Hi-Fi Products
Service Bulletin

Model: CDP-C100

No. 187

Subject: M602 Motor PC Board

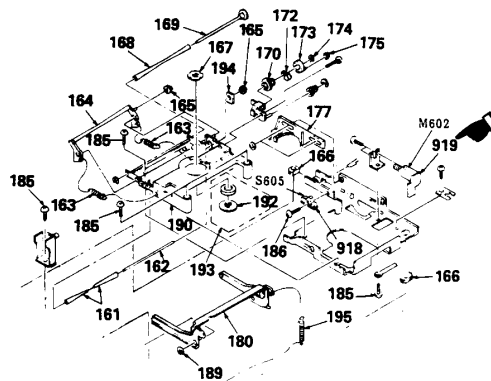
A replacement motor (P/N X-4308-360-A type FF-130SH) will be sent out whenever the M2 motor (A-4608-360-A) is ordered.

Solution: It is necessary to order the M2 P.C. board at the same time. This is because the new motor type does not fit on the old board.

Ref. No.	Description	Part Number
M602	Type FF-280SA	X-4308-360-A
919	PC Board, M2	1-626-868-11
